City Planning Commission
Sacramento, California

Subject: A. Negative Declaration

B. Variance to Reduce the 50% Parking Lot Shading Requirement to 27%

Location: 2250 Cormorant Way

MODIFIED PLAN

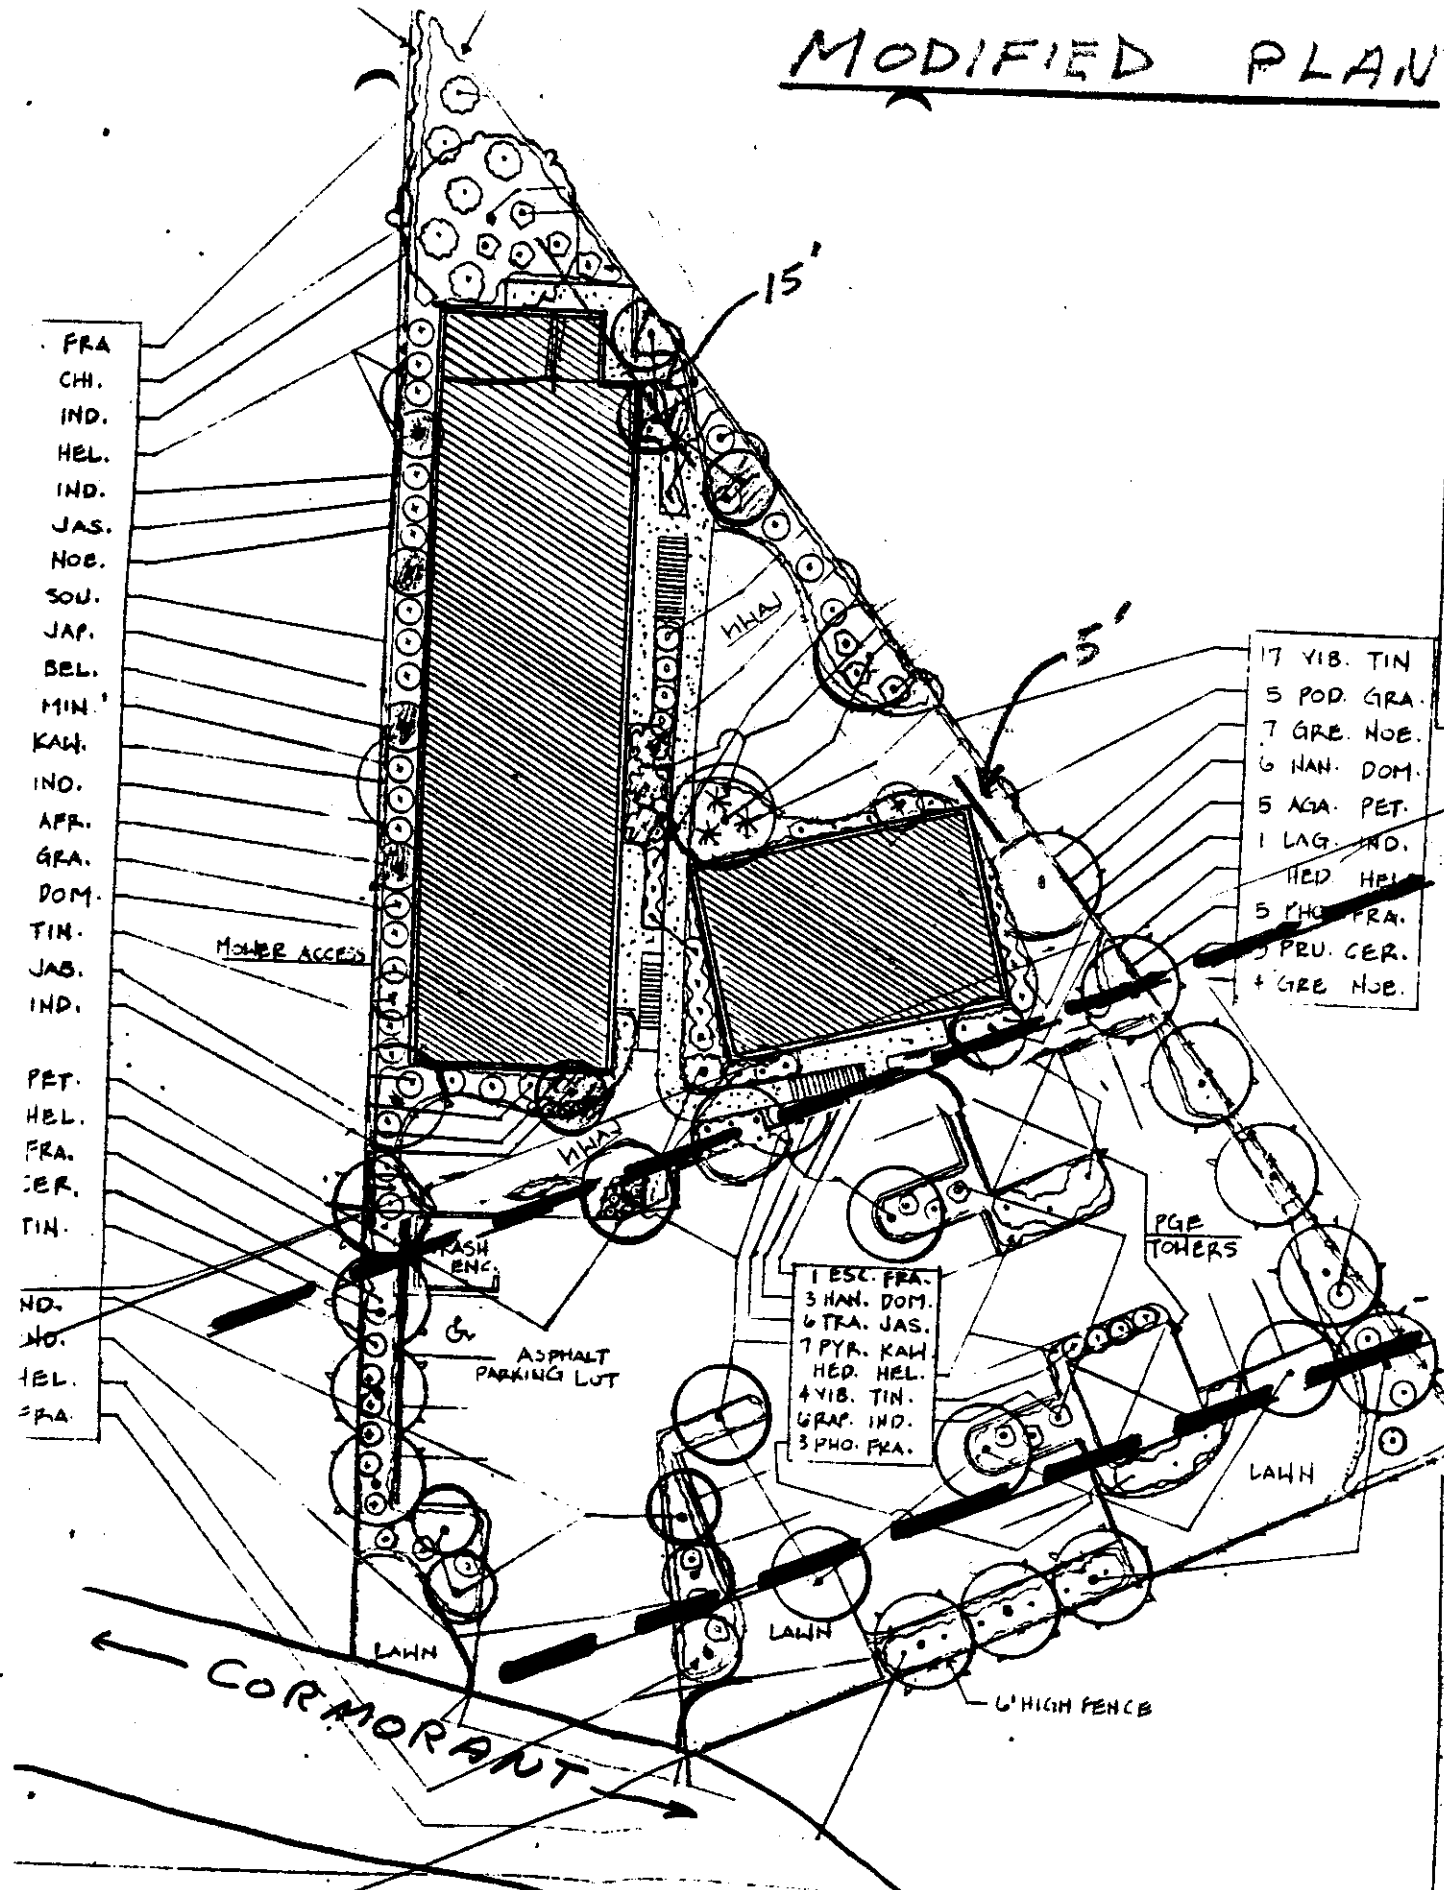
The applicant has submitted a revised plan whereby the larger structure (10 units) is relocated within five feet of the northerly property line adjacent to the public park. The smaller two story structure (four units) is relocated to the south approximately five feet from the sideyard property line. The south elevation of this building does not contain any windows. The applicant also proposes to plant trees along the south property line to provide additional screening from the apartments.

Staff has re-evaluated the project and inspected the site and found that due to the irregular shape of the lot and the location of the transmission towers and lines, the actual buildable area is severely limited. Staff agrees with the applicant's modified plan. However, staff suggests further modification be made by reducing the height of the four unit structure from two to one story and reduce the structure to two units. This will reduce the mass and improve the overall appearance of the project from the street and neighboring properties. The planting of additional trees along the south property line will also provide screening.

1. The applicant shall provide a minimum of 27% shading for the proposed parking lot.
2. Revised landscape/irrigation plans shall be submitted to the Building Inspections Division that are drawn to scale for review and approval.
3. The applicant shall develop the project as indicated in the modified plan Exhibit A, except the smaller structure shall be one story in height and contain two units (total 12 units).
4. Additional trees (evergreen) shall be planted along the south property line. The revised landscape plan shall indicate these trees.

IRRIGATION PLAN

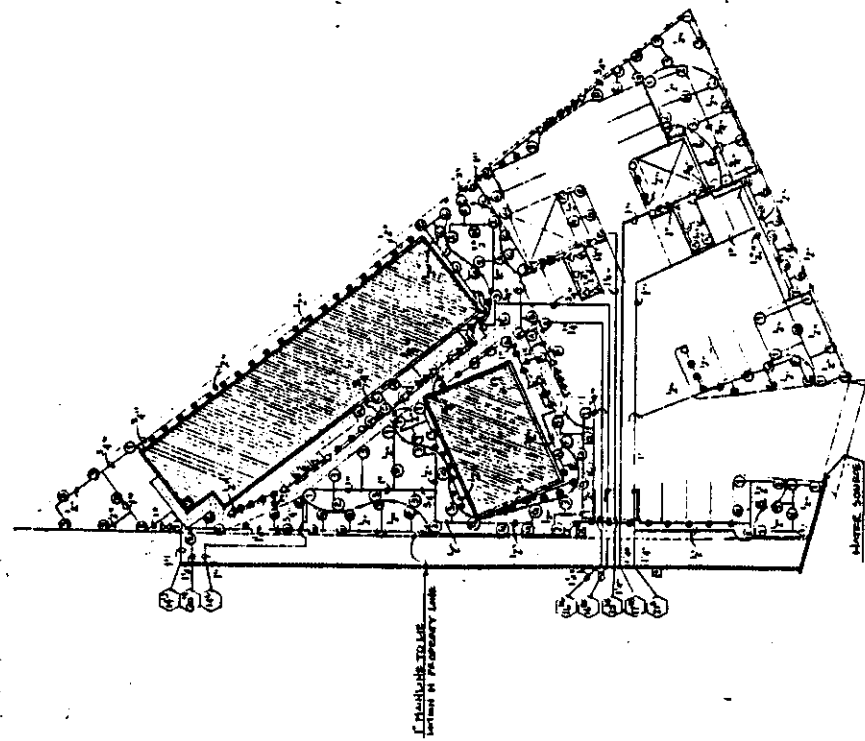
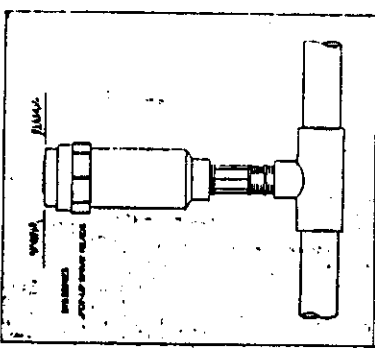
Provide landscape plans to scale. Present plans are out of scale.

1. The applicant shall provide a minimum of 27% shading for the proposed parking lot.
2. Revised landscape/irrigation plans shall be submitted to the Building Inspections Division that are drawn to scale for review and approval.
